Revised 1st Floor Renovation Plan
1/8"=1'-0

Ochsner Clinic
Renovations and Additions
22070 La Hwy 59
Abita Springs, LA 70420

02/13/2010	2004-20
Fire Marshal	Ochsner4.dwg

1
SK-1

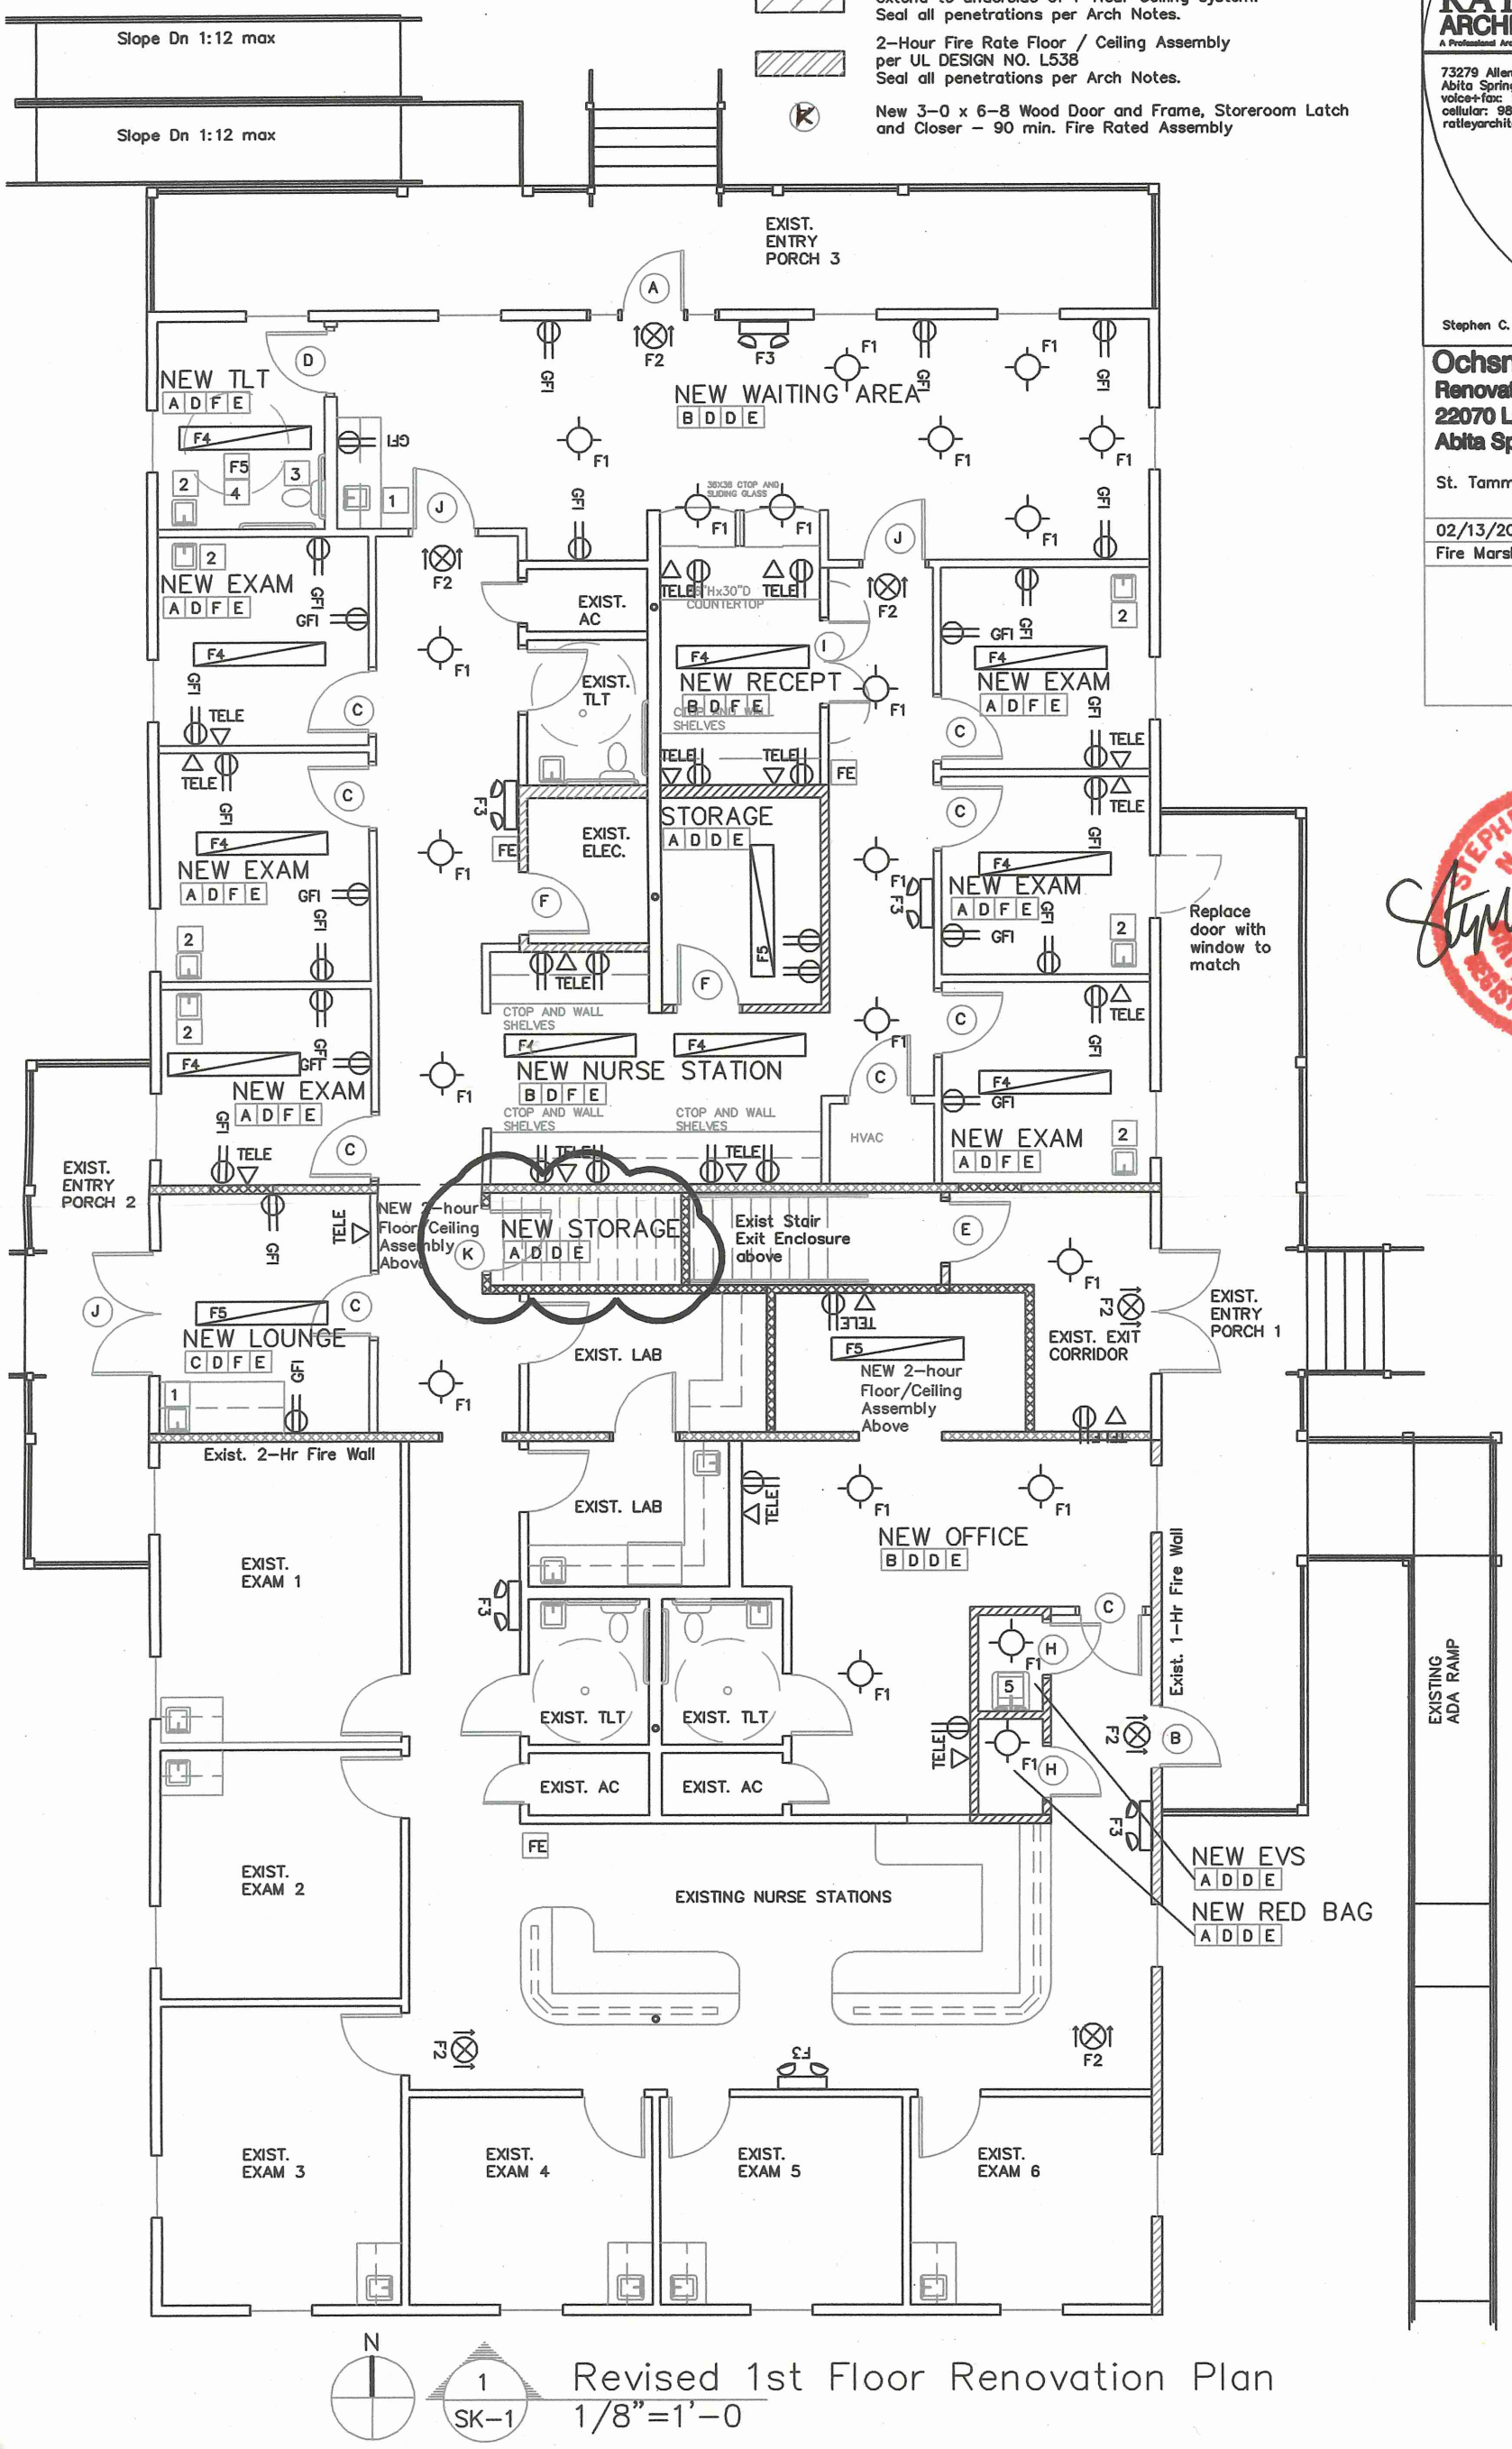
2-Hour Fire Barrier, UL Design No. U-301
extend to underside of floor and roof deck.
Seal all penetrations per Arch Notes.
Install Fire Dampers in all Duct penetrations.

1-Hour Fire Barrier, UL Design No. U-305
extend to underside of 1-Hour Ceiling system.
Seal all penetrations per Arch Notes.

2-Hour Fire Rate Floor / Ceiling Assembly
per UL DESIGN NO. L538
Seal all penetrations per Arch Notes.

New 3-0 x 6-8 Wood Door and Frame, Storeroom Latch
and Closer - 90 min. Fire Rated Assembly
